From: Johnston, Alex [Alex.Johnston@lr.org]
Sent: 08 January 2007 12:20
To: Johnston, Alex
Subject: FW: CSR-BC Relative displacement of transverse bulkhead

1. Could you forward our question below to IACS PT with respect to JBP Ch 8 Sec 4 2.3.6 for fatigue analysis of longitudinals in way of T.BHD.

Figure 3: Relative displacement between the transverse bulkhead and the transverse web or floor

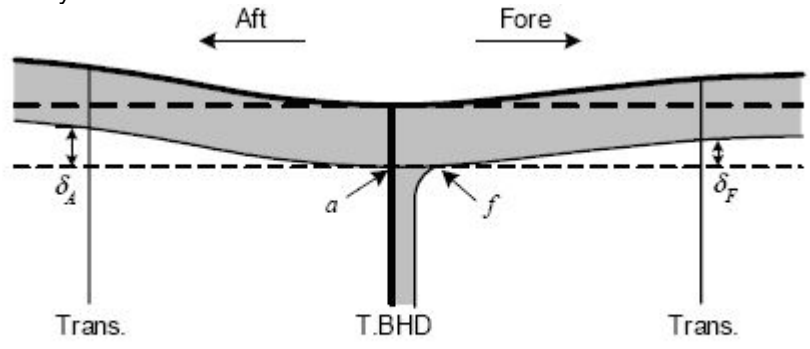
2. Relative displacement δ_A , δ_F ;

Example displacement in alternate condition is shown below with undeformed shape. We have considered how to treat this relative displacement and some ideas are illustrated. Could you confirm which interpretation (Case 1 ~ 3) is correct?

Case 1 Measured in global Z coordinate (vertical direction);

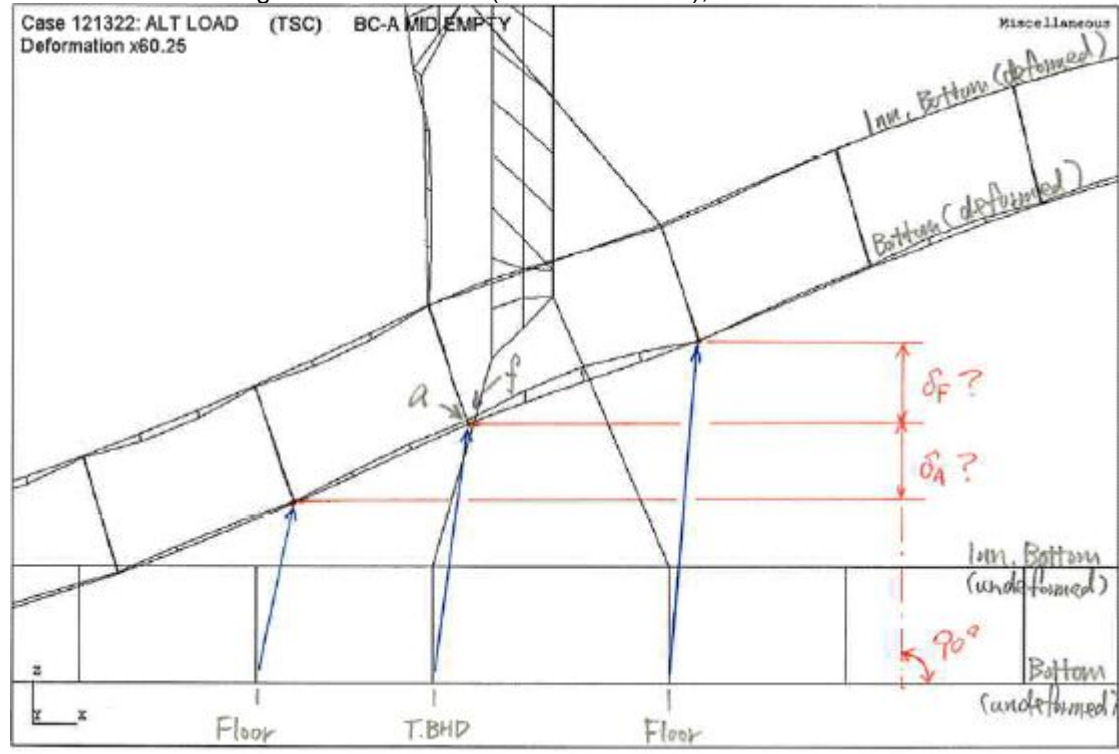
2.1. On bottom shell;

Case 1 Measured in global Y coordinate (transverse direction);

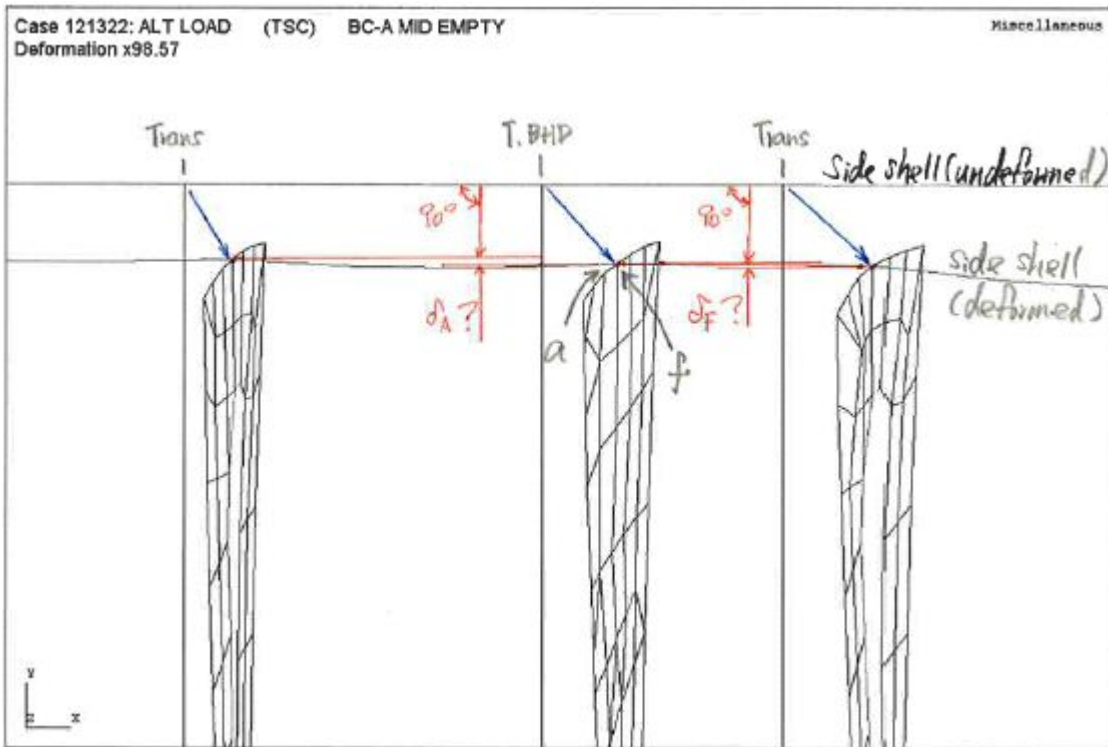
2.2. On side shell;
